NLR Planning Commission
January 10, 2017
Agenda Meeting / Public Hearing 4:00 PM

**North Little Rock Planning Commission
Regular Meeting
December 13, 2016**

B. SD2017-2 Lakewood Addition, Lot 1R, Block 60 (Site Plan Review of offices with indoor storage located at 4500 North Hills Blvd)

LOT 1R, BLOCK 60, LAKEWOOD ADDITION
TO THE CITY OF NORTH LITTLE ROCK,
PULASKI COUNTY, ARKANSAS

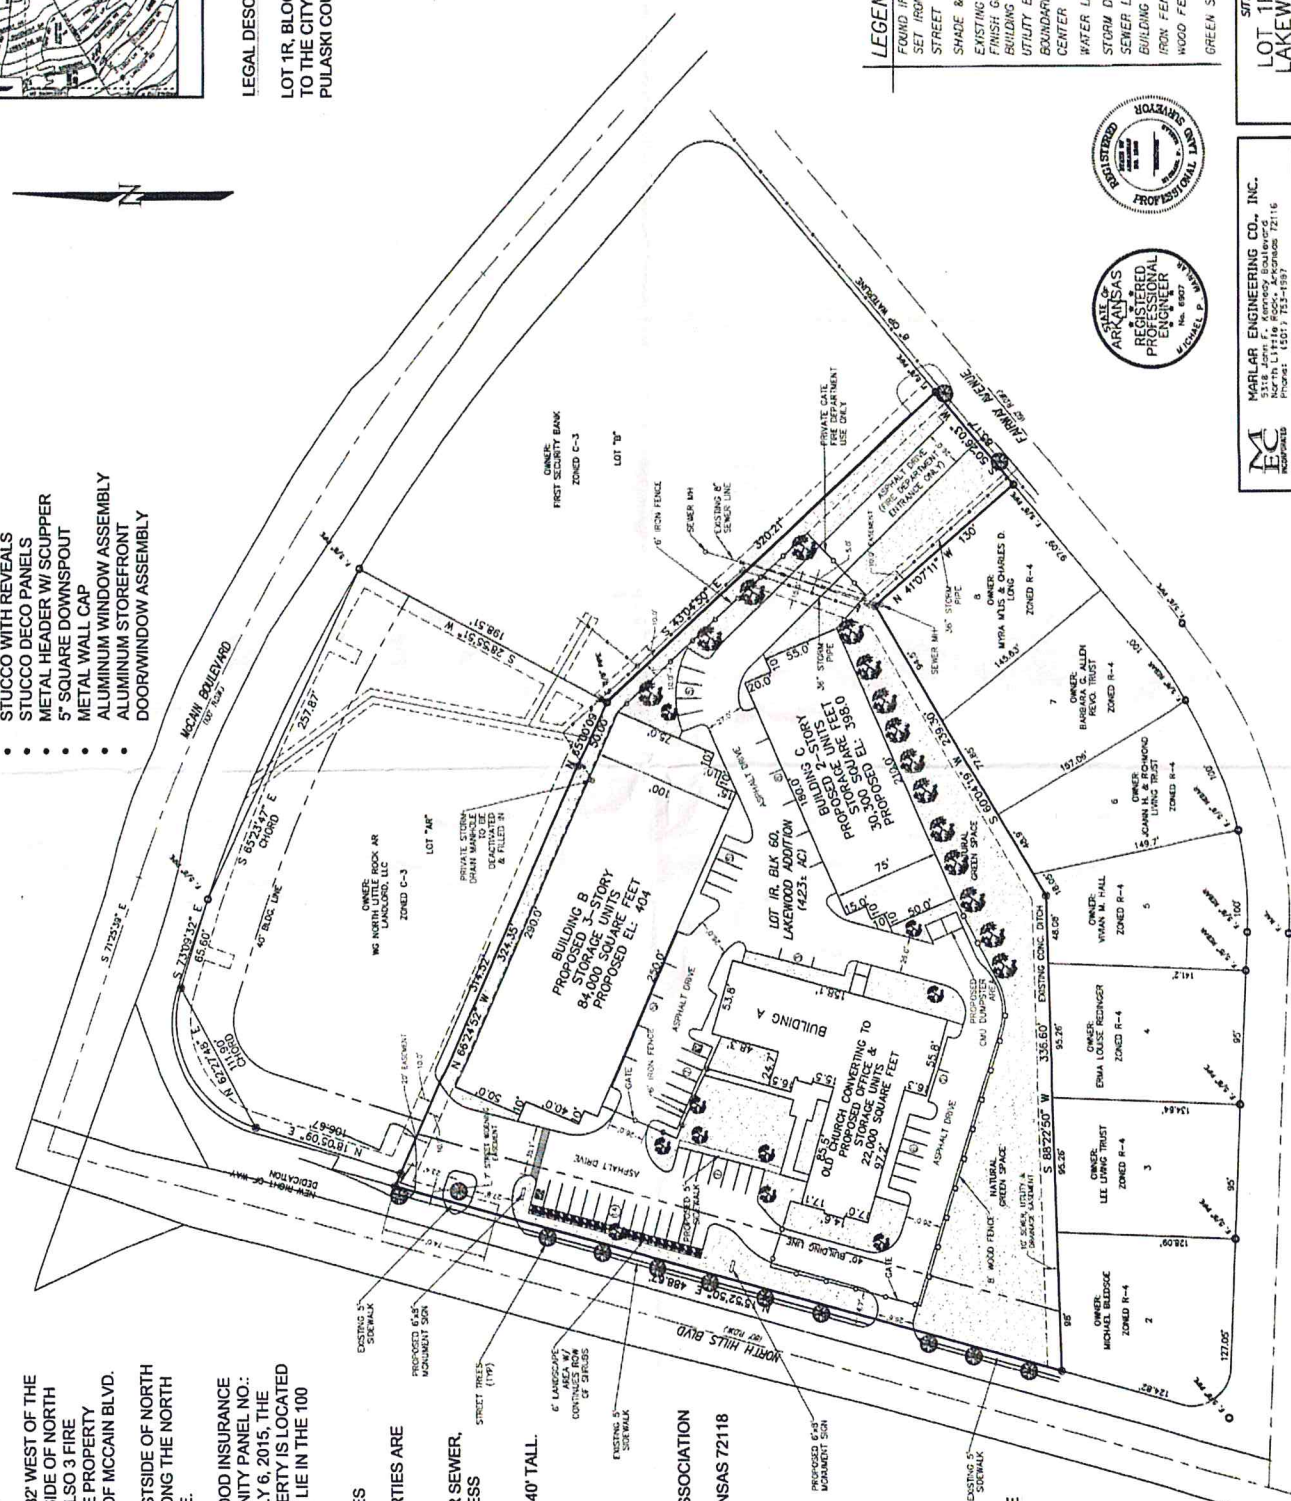
- 1. Provide the following items associated with a PUD zoning change.**
 - a. Building elevations (B and C).
 - b. Building heights (A, B and C).
 - c. Typical material list (B and C).

- e. Show stormwater easement for existing storm lines within Building B footprint, and make any manhole relocation adjustments as needed to be shown on plans or provide proof that easement has been abandoned.

- 11. Meet the requirements of NLR Wastewater, including:**
- a. A complete set of drawings for development must be submitted to NLR Wastewater. Provide plumbing plans for buildings B and C, if applicable.

- b. Show sanitary sewer main crossing the property.
 - c. Approval of plans by AR Dept of Health Engineering Division is required.
- 12. Meet the requirements of Rock Region Metro (CATA), including:**
